**ALERT SERVICE BULLETIN**  
REVISION NOTICE  
**Bell Helicopter** **TEXTRON**  
A Subsidiary of Textron Inc.

**SUBJECT: REVISION "D" TO ALERT SERVICE BULLETIN 205-00-80 (TAIL ROTOR BLADE 212-010-750-009 THROUGH -129 TIP BLOCK MODIFICATION)**

NO. 205-00-80

**SUBJECT:** TAIL ROTOR BLADE P/N 212-010-750-009  
THROUGH -129, TIP BLOCK RETENTION  
MODIFICATION

**Figure 1**  
**212-010-750 - ALL**  
**TAIL ROTOR TIP RETENTION MOD**

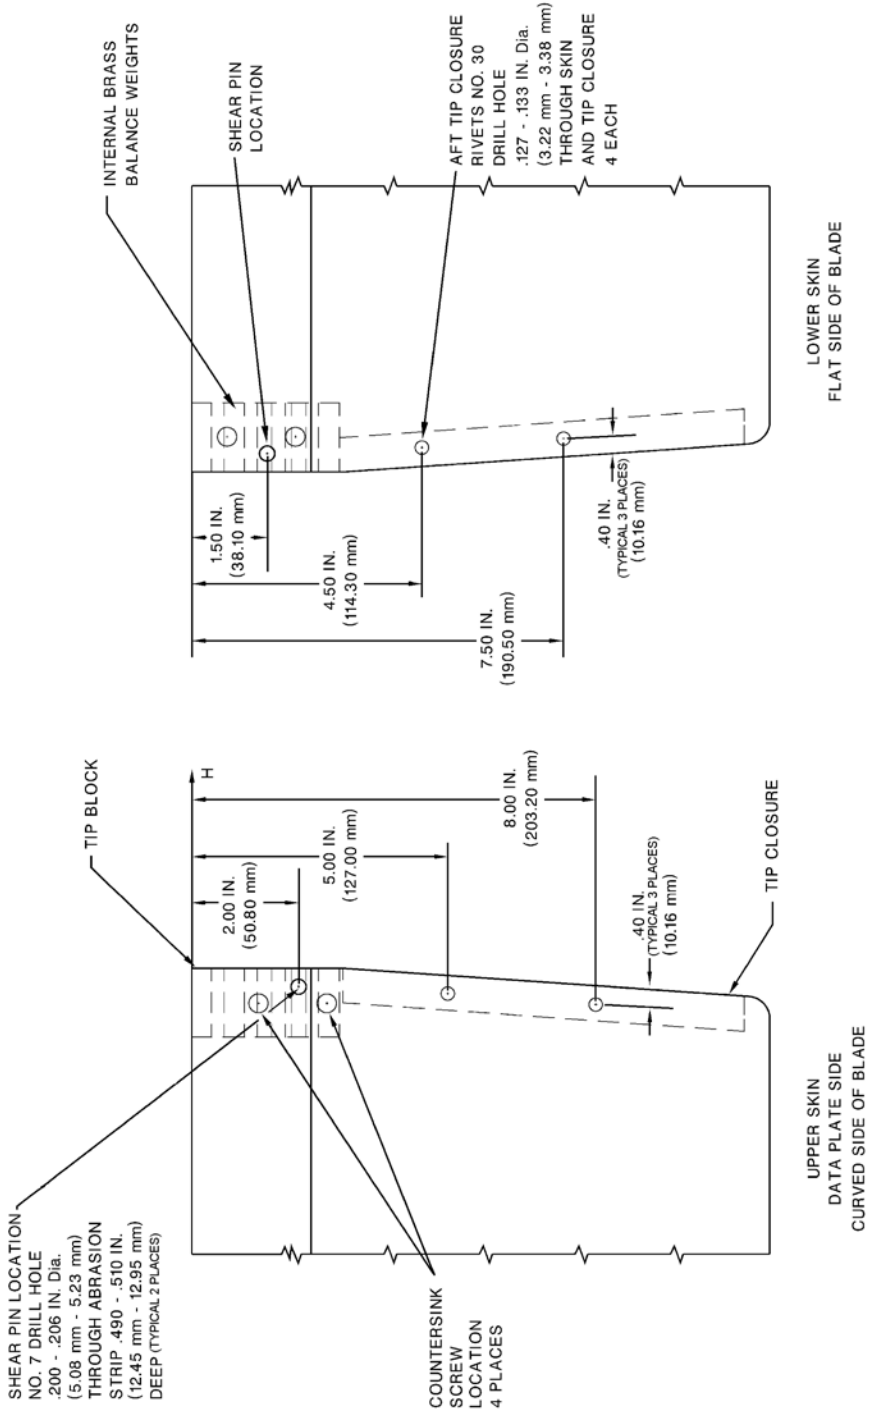
**Revision "D"** to this bulletin provides an alternate fastener for the tail rotor blade tip closure rivets installation.

This alternate rivet P/N NAS9307M-4-01 has a monel sleeve which is more erosion-resistant. Installation of this rivet with sealant MIL-PRF-81733 in lieu of adhesive 299-947-100 TY2 CL 2 will offer a better protection against water contamination and corrosion. An oversize rivet P/N NAS9310M-4-01 is also added to the material list.

1. Deleted
2. Inspect forward tip weight retention block and aft tip closure for voids. Remove any blade from service that exhibits voids in excess of CR&O limitations.
3. Inspect forward tip block attachment countersink screws. 4 locations. See Figure 1. Inspect to insure that the head of the countersunk screw is flush with the surface of the abrasion strip.
4. T/R blades that have the screws flush with the surface of the abrasion strip in all 4 locations do not require shear pin installation. T/R blades with one or more of the screws that are set below the surface of the abrasion strip or are covered with filler material may not provide acceptable retention of the tip block in the event of adhesive failure and will require shear pin installation. The limit is flush to 0.010 inch (0.0254 mm) high.
5. The aft tip closure rivet installation must be accomplished on all tail rotor blades.

1. Using a clean, sharp No. 7 drill bit, drill a **.50** inch deep shear pin installation hole as shown on Figure 1. The upper surface of the blade can be identified as the curved side of the blade and is same side as the data plate. Likewise the lower surface of the blade is the most flat side of the blade. The shear pin installation holes are located at 2.0 inches (projected) aft of the leading edge on the upper surface and 1.5 inches (projected) aft of the leading edge on the lower surface.

1. Using a clean, sharp no.30 drill bit, drill two rivet installation holes on both the upper and lower surface of the blade tip as shown in Figure 1. It is not necessary to remove the paint in the area.

2. De-burr drilled holes and verify rivet fit. Clean M7885/2-4-01 or NAS 9307M-4-01 rivets and drilled holes with Aliphatic Naphtha. Wipe dry before solvent evaporates.

3. Obtain a kit of sealant per MIL-PRF-81733. Thoroughly mix the accelerator, add it to the base product, then thoroughly mix the mixture until a uniform color, devoid of streaks, is achieved.

4. Coat rivet-shanks with MIL-PRF-81733 sealant and install verifying that rivet heads are seated firmly with blade skin. Allow a fillet of adhesive to squeeze out around rivet heads to insure blade is sealed.

5. Allow sealant to cure for 24 hours at room temperature. Refinish rivet heads in accordance with 205 MM for blade refinishing. Re-identify the modified blade by the addition of "FM" after the part number (i.e., 212-010-750-109FM).
